### **Crudine Ridge Wind Farm (Mod 1)**

Thank you for the opportunity to make a submission opposing the Crudine Ridge Wind Farm (Mod 1) to increase the limit for tree clearing along the access road, to align the proposal with the EPBC Act imposed limit of 37 turbines **AND to increase the blade length to 68.5m.**

Attachment 1 Crudine Ridge (Mod 1) Impact Summary: showing differences between a swept area of 40m and 68.5m radius

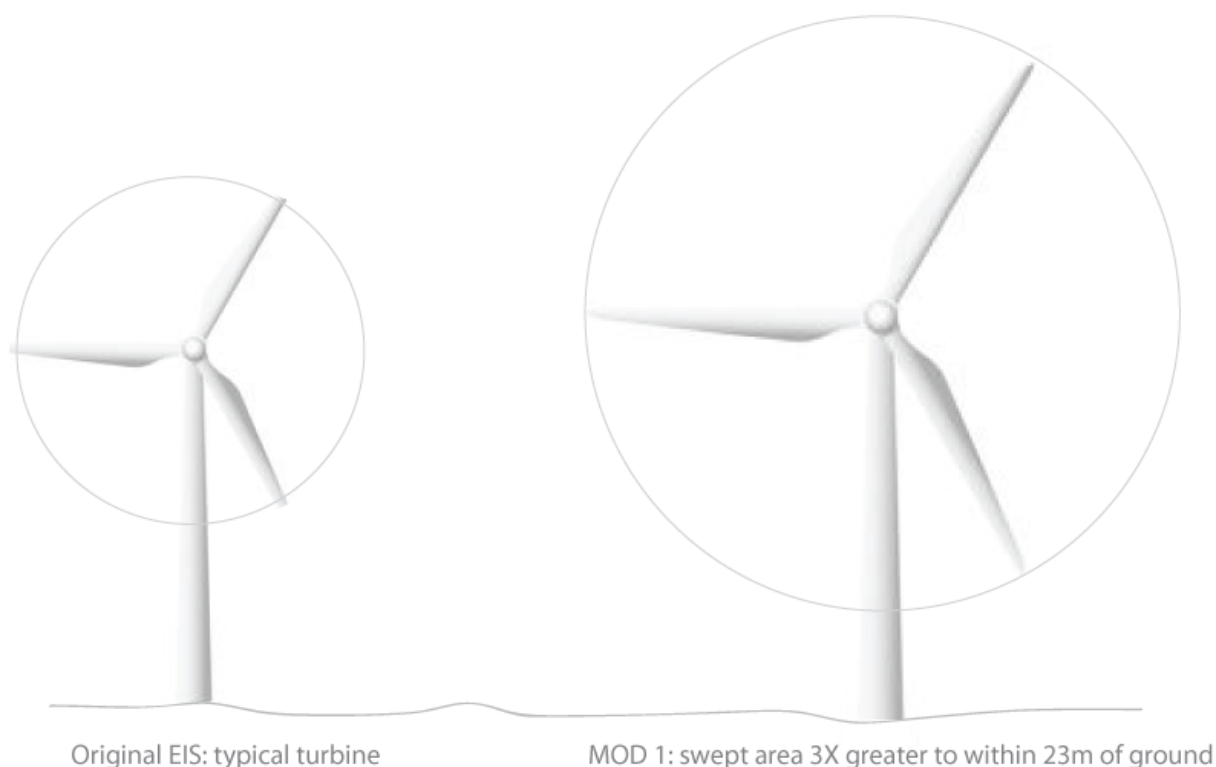
I have based my submission on a worst-case scenario to increase the blade length from 40m to 68.5m, that is a 193% increase in the swept area and which will bring the blades down to a height of 23m above ground. Given that the EPBC Act decision was a significant reduction in turbines because of concerns for threatened species including bat and bird strike and capped the number of turbines at 37, the impact of the increased blade length requires careful assessment.

The original EIS mentions smaller blade lengths and presented calculations for roadside clearing based on a smaller blade. Mod 1 proposes a blade length of 68.5m which means a tower height of 91.5m thus bringing the blade down to 23m above ground. The swept area will be  $\sim 15,000\text{m}^2$  as compared to a swept area of  $5,000\text{m}^2$ . In other words, Mod 1 will increase the swept area 193% and will bring the blades nearly twice as close to the ground as the typical blade mentioned in the EIS.

- The three-fold increase in the swept area will have a significant impact on bat and bird strike, including threatened species and increase the bird migration barrier. Additional impacts should be neither accepted nor approved.

- Lowering the swept area to within 23m of the ground will have a significant impact on a wider range of bird species including woodland birds and parrots which fly closer to the ground. Additional impacts to threatened species should be neither accepted nor approved.
